ROTAX 503 UL DCDI (Serie), "B" - Getriebe Montage

ROTAX 503 UL DCDI (all versions), "B" type gearbox installation

(siehe Bild 1)

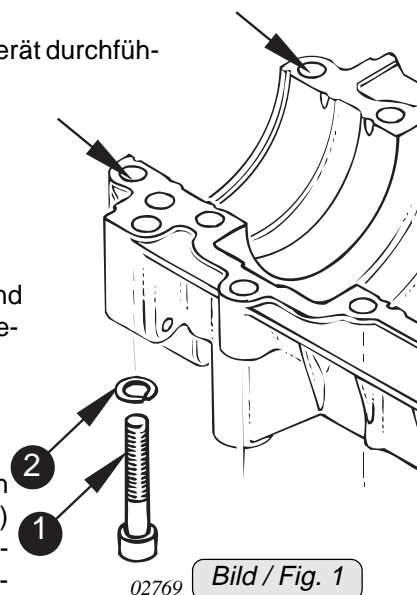
Aufgrund der Standardisierung wurde die Lage der vorderen Gehäuseschrauben (siehe Bild 1) geändert. Die beiden Schrauben (T.Nr. 841.561) wurden durch die Schrauben (T.Nr. 640.611) ersetzt.

In the course of standardization the location of the front crankcase fasteners (see fig. 1) has been changed. The two screws (part no. 841.561) have been replaced by the screws (part no. 640.611).

Die Zylinderschrauben (T. Nr. 841.561) sind durch die Zylinderschrauben (T. Nr. 640.611) gemäß nachstehender Arbeitsanweisung zu ersetzen, sofern ein "B" Getriebe eingesetzt werden soll.

The Allen screws (part no. 841.561) have to be replaced by the Allen screws (part no. 640.611) if a "B" type gearbox is going to be fitted.

- Die beiden Schrauben (1) entfernen.
- Neue Schrauben mit neuem Federring (2) einschrauben und mit geeigneten Werkzeug (6 DIN 6911) mit 22 Nm festziehen.
- Getriebe gemäß Service Information SI 12 UL 94 montieren.
- Motorprüflauf durchführen.

- Remove the two screws (1).
- Fit the new type screws along with lock washer (2) using Allen key (6 DIN 6911) and tighten to 22 Nm (195 in.lb).
- Install gearbox as per Service Information SI 12 UL 94.
- Conduct engine test run.

■ **Attention:** Use of the screws (part no. 841.561) on the new crankcase (part no. 887.798) could result in damage of gear cover at installation of a "B" type gearbox. Therefore employment of these screws is not permitted.
